**SUBJECT:** Rezoning Application

To permit nine (9) detached dwellings on a CEC - private road

1629 Blanefield Road

Supplementary Report

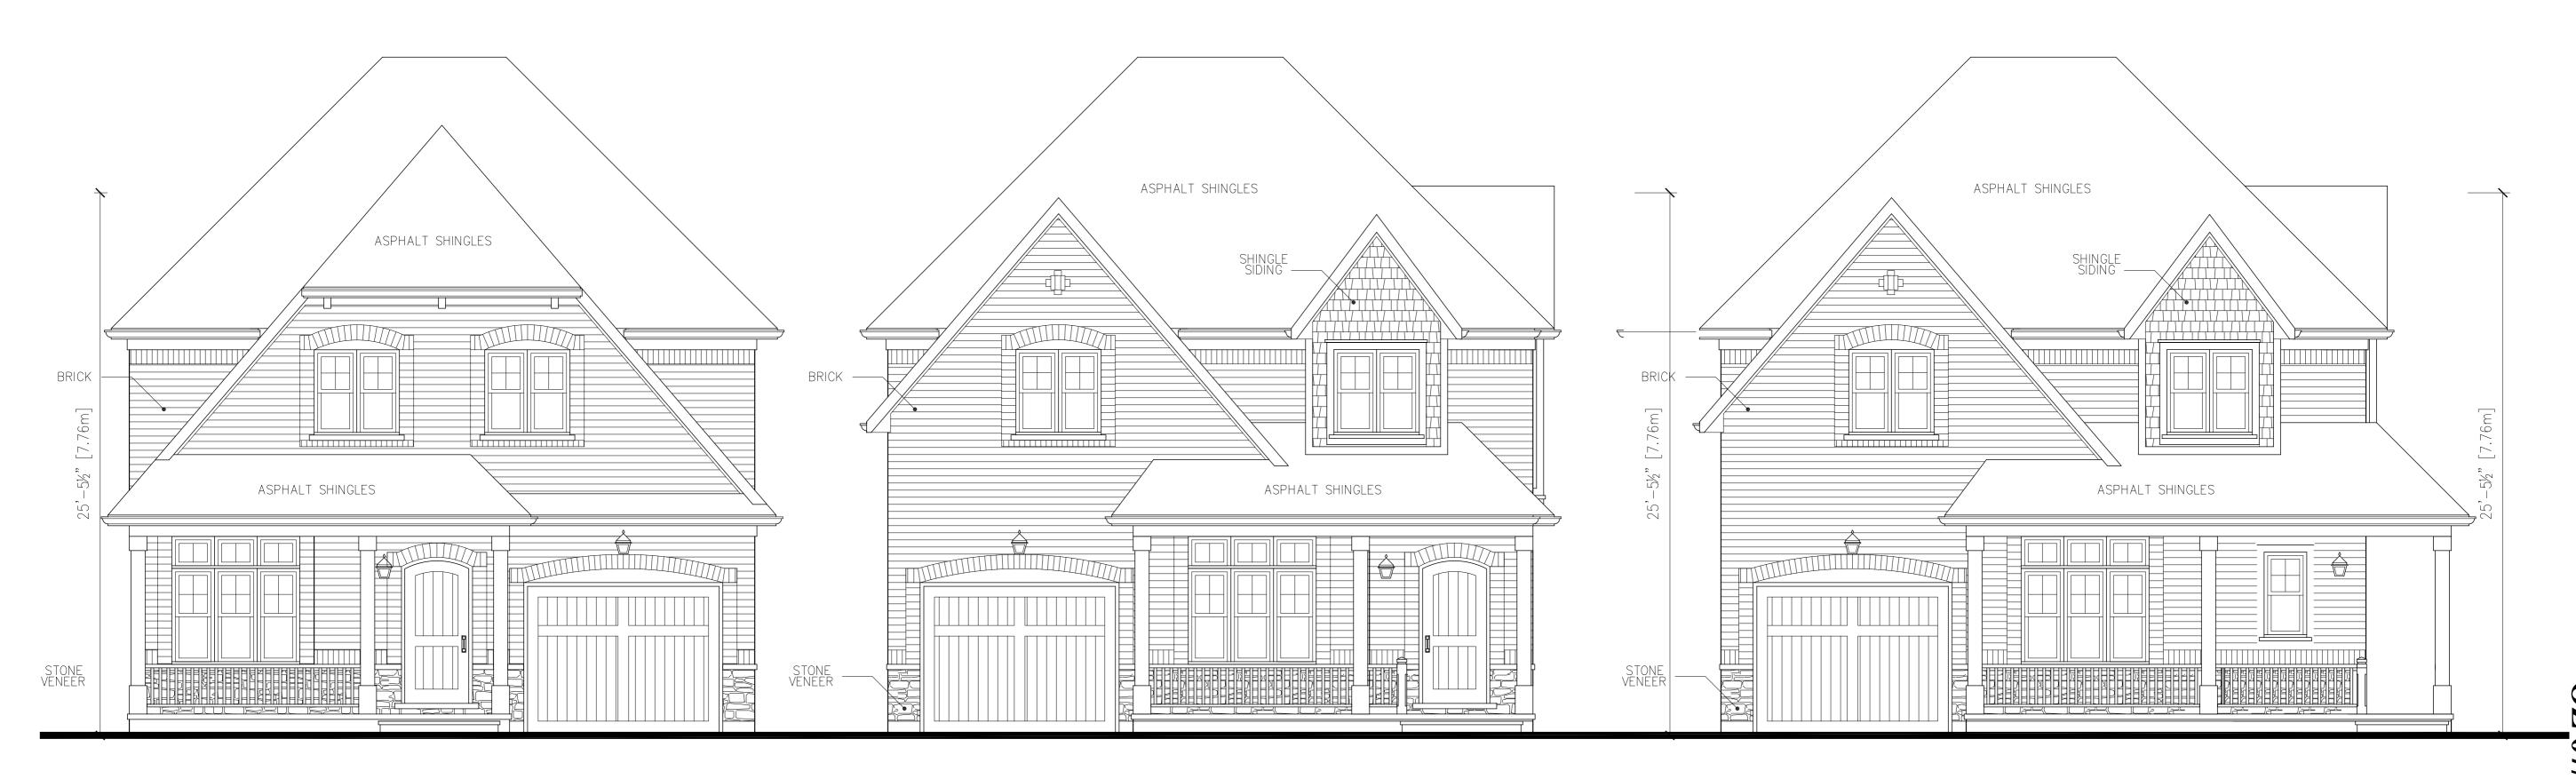
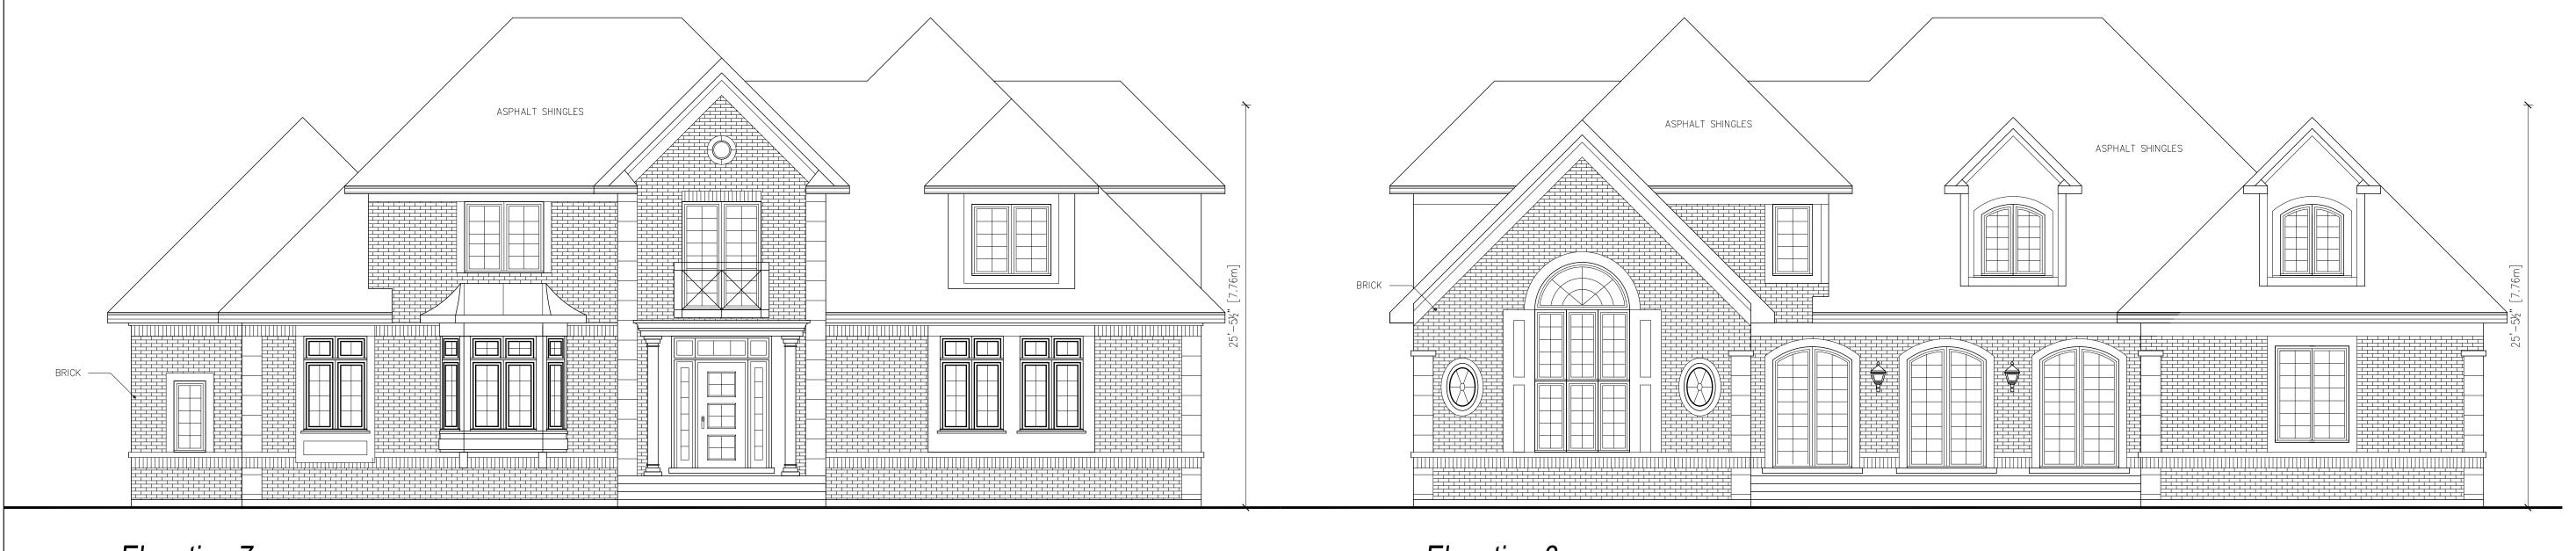
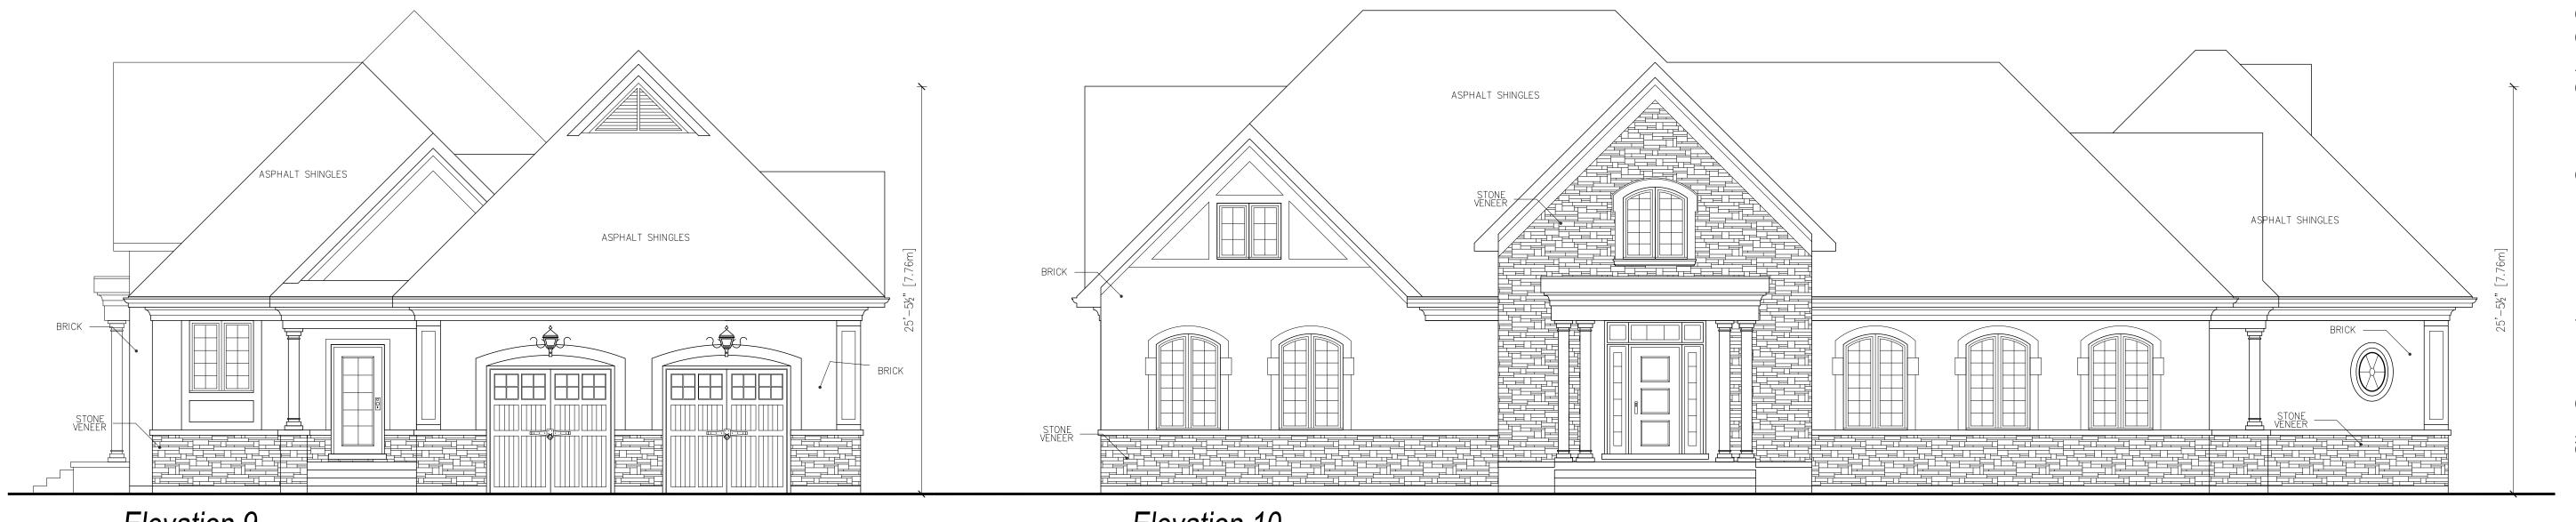
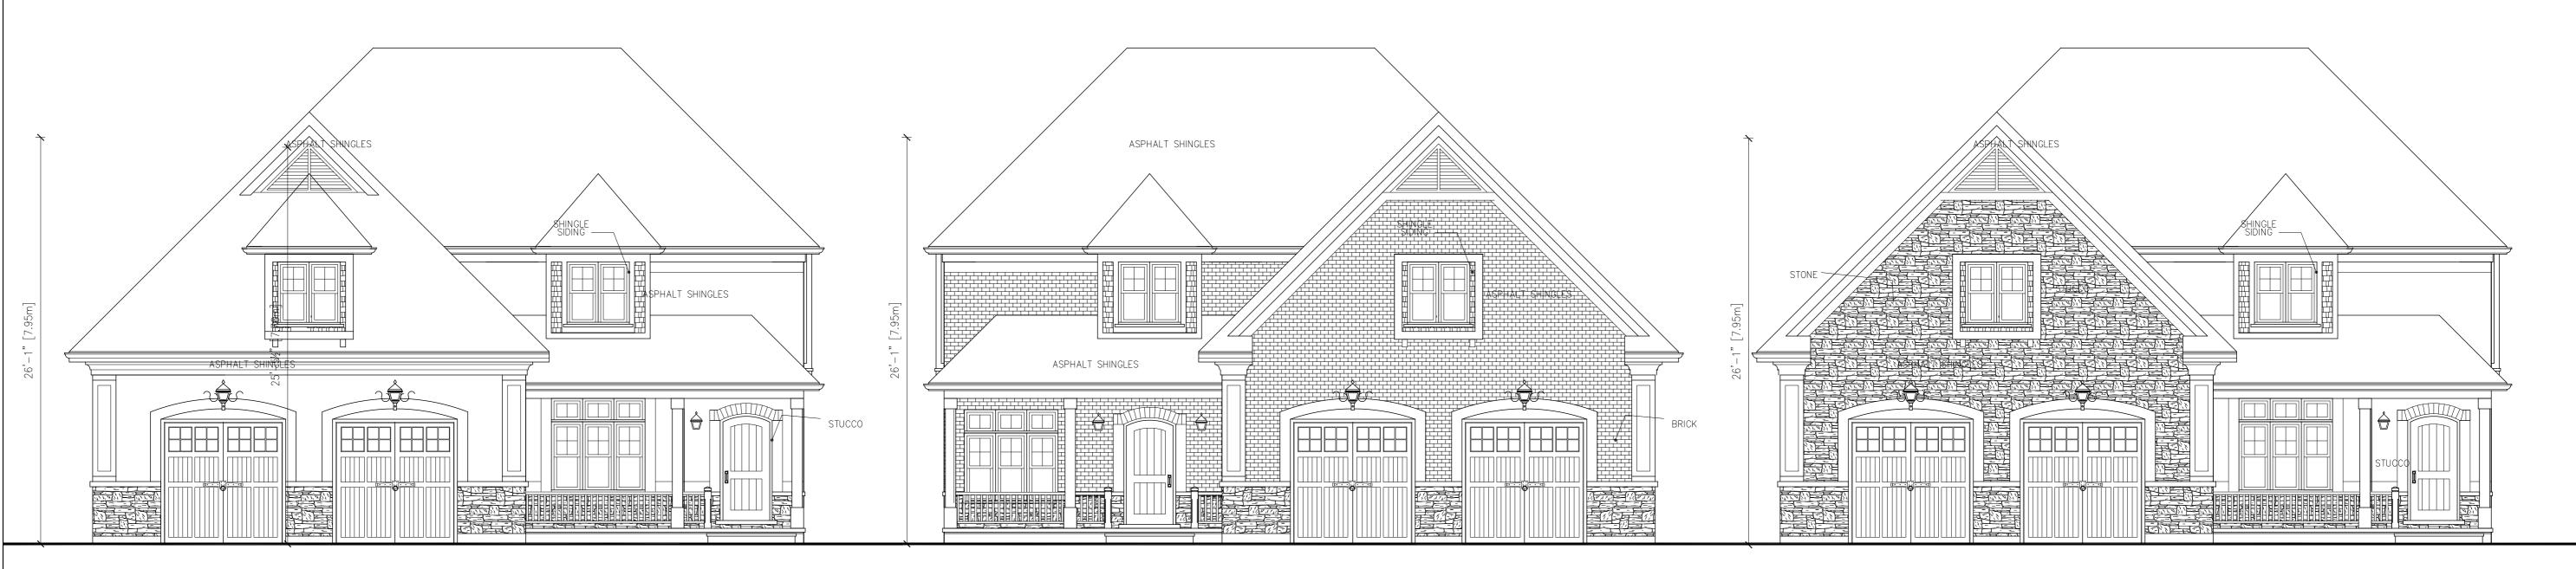
The applicant has provided conceptual elevations for each of the proposed units. Through the processing of the application, staff will require that the elevations meet the intent of the Infill Housing Policies (S. 4.24.3.1) of the Mineola District. The proposed elevations facing the public street for Lots 5-7 (see Appendix I-6, page 3) should be revised to de-emphasize the height of the buildings and be designed as a composition of smaller architectural elements.

An issue was raised in the Information Report regarding the proposed elevations for the dwellings facing the public street and the need for these units to meet the intent of the Infill Housing Policies (S. 4.24.3.1) of the Mineola District with respect to deemphasizing the height of the buildings and to be designed as a composition of smaller architectural elements. Through the site plan approval process, the City will ensure that the proposed dwellings appropriately address the principles included in the Infill Housing policies.
